SUBJECT: Forwards addl info requested in 990513 ltr to support review  
 of pending response to GL 95-07, "Pressure Locking & Thermal  
 Binding of Safety-Related Power Operated Gate Valves."

Subject: WNP-2, OPERATING LICENSE NPF-21  
RESPONSE TO GENERIC LETTER 95-07, "PRESSURE LOCKING AND  
THERMAL BINDING OF SAFETY-RELATED POWER OPERATED  
GATE VALVES" (ADDITIONAL INFORMATION)

**RESPONSE TO GENERIC LETTER 95-07, "PRESSURE LOCKING AND THERMAL BINDING OF SAFETY-RELATED POWER OPERATED GATE VALVES  
(ADDITIONAL INFORMATION - TAC NO. M93539)**

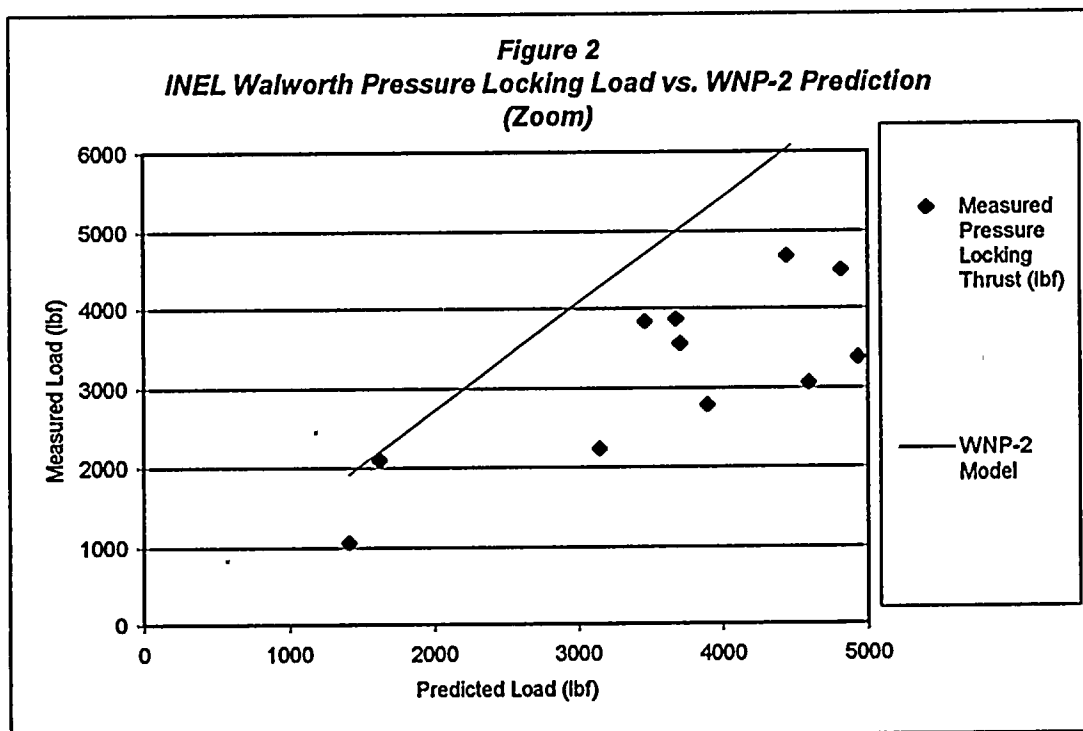
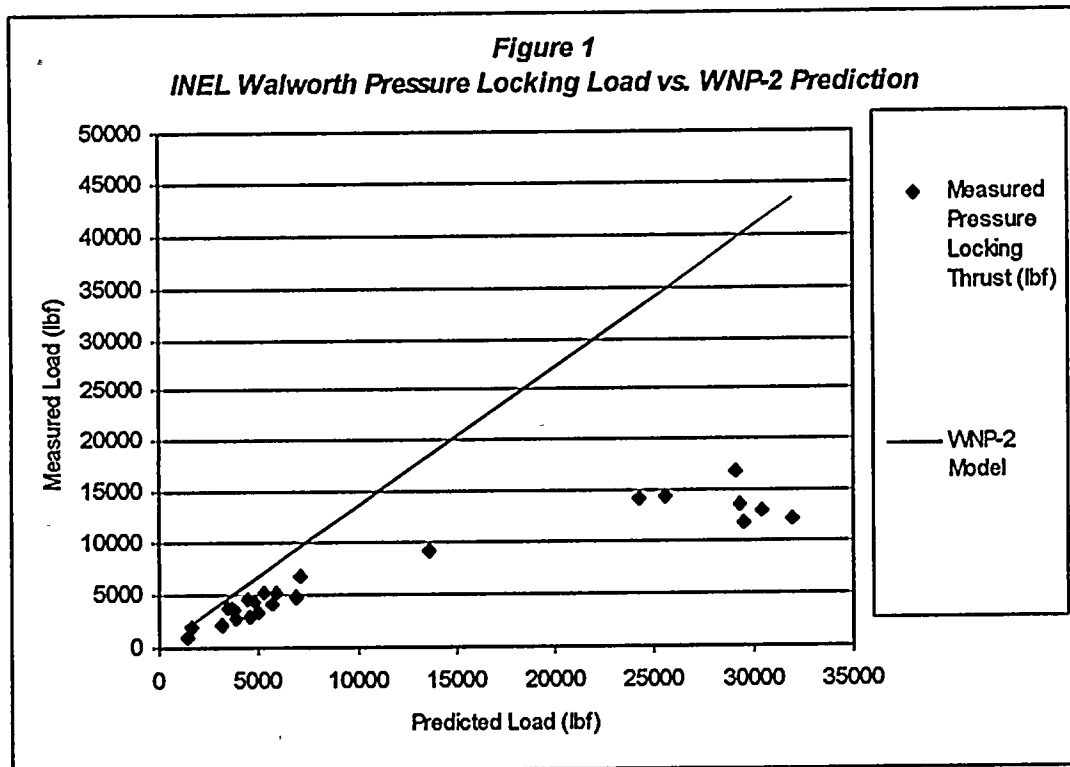
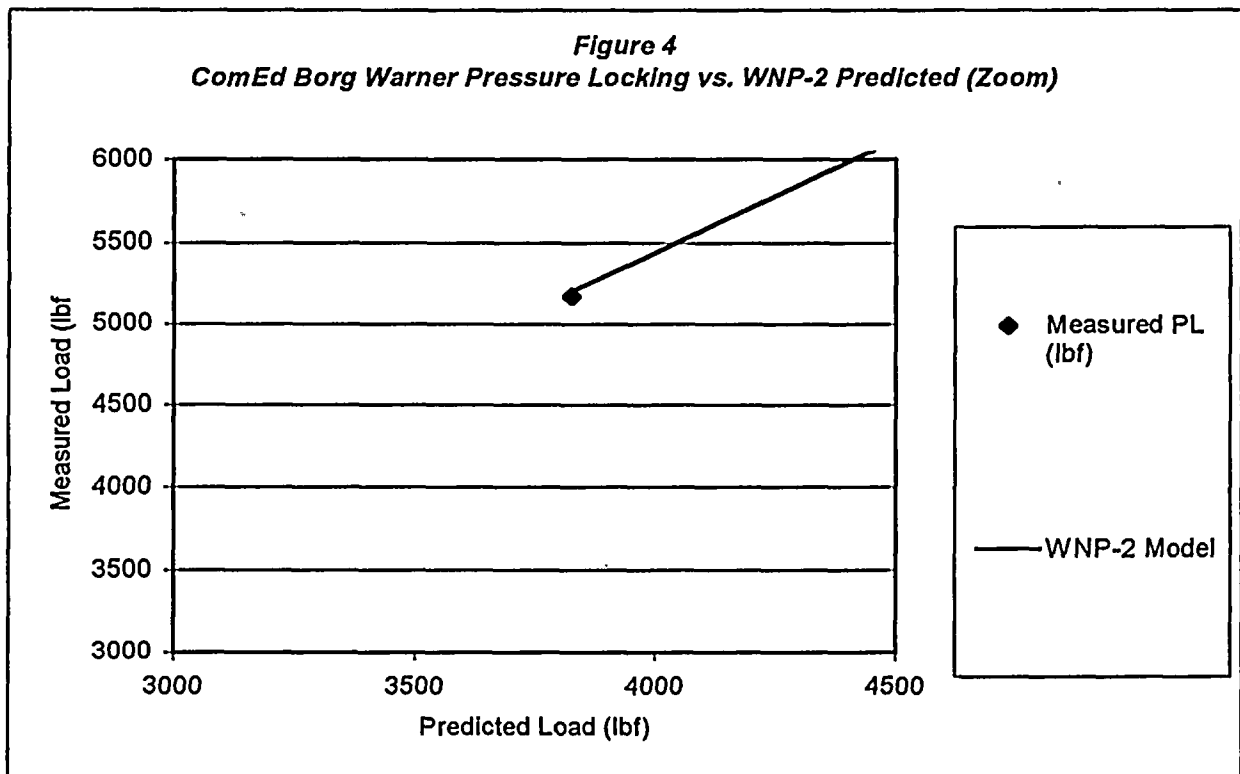
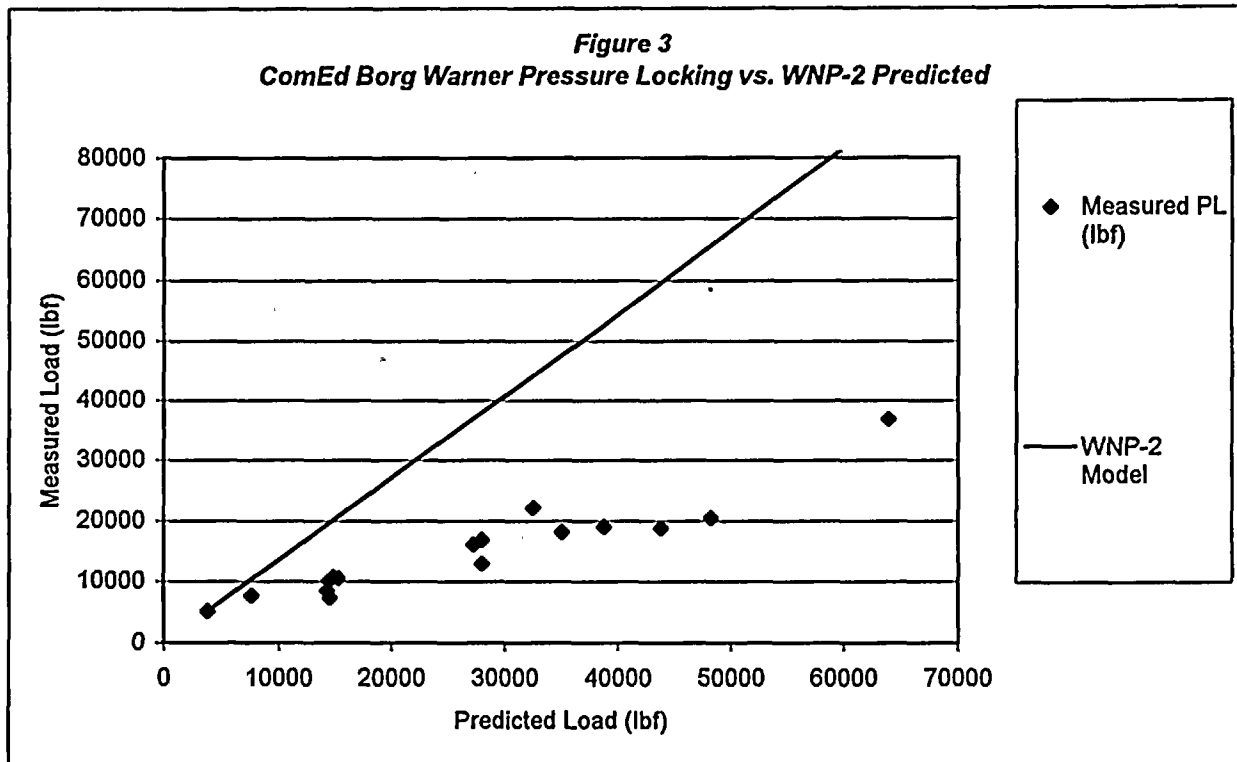
Figures 1 - 6 show the results of the predicted pressure locking loads using the WNP-2 model as compared to loads measured during industry testing. In addition, the horizontal axis represents the load predicted by the simple model and the vertical axis represents both the measured load for the industry-tested valves and the value predicted by the WNP-2 model. The comparisons show the WNP-2 model over predicts (in most cases significantly) the actual load for all tests, especially those at higher bonnet pressures. This is expected given that the simplified model conservatively accounts for a disk hub area load (bonnet pressure x the disk hub area x 2) that in reality is not present. This effect is magnified at greater pressures.

**Figure 5**  
**Crane Measured Pressure Locking Loads vs. WNP-2 Predicted**

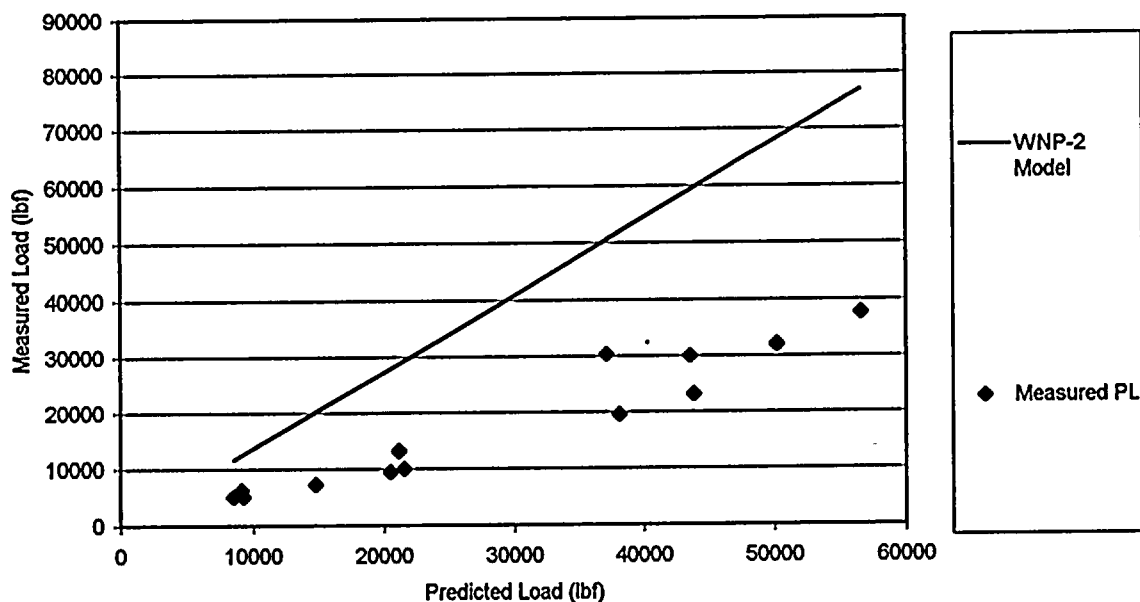
2b. As discussed in the response to question 2a, the WNP-2 model over predicts pressure-locking loads compared to both the ComEd and INEL data. In addition, the ComEd and INEL valves used to justify the WNP-2 pressure locking method (Equation 2) are appropriate comparisons to the WNP-2 CAC 2, 6, 8, 11, 13, 15, and 17 valves. This is supported by the following observations:

2. The Crane and Westinghouse valves tested by ComEd provide an effective comparison due to their more "rigid" bodies (both have a class rating greater than 600 pounds). Since they are made of forged material, the WNP-2 valves are also considered "rigid." Per the results of ComEd and INEL testing, valves with rigid bodies (pressure classes greater than 600 pounds and/or those with forged bodies) will flex less than lighter class or cast valves when subject to pressure locking. This effect results in a comparatively less required thrust to open under pressure locking conditions.
